4420 GREEN MOUNTAIN DRIVE

GRADING AND EROSION CONTROL PLAN

COUNTY PCD NO: CDR2612

AGGREGATE VEHICLE TRACKING CONTROL

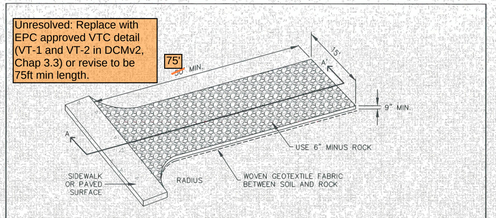
Unresolved: Replace with EPC approved VTC detail (VT-1 and VT-2 in DCMv2, Chap 3.3) or revise to be 75ft min length.
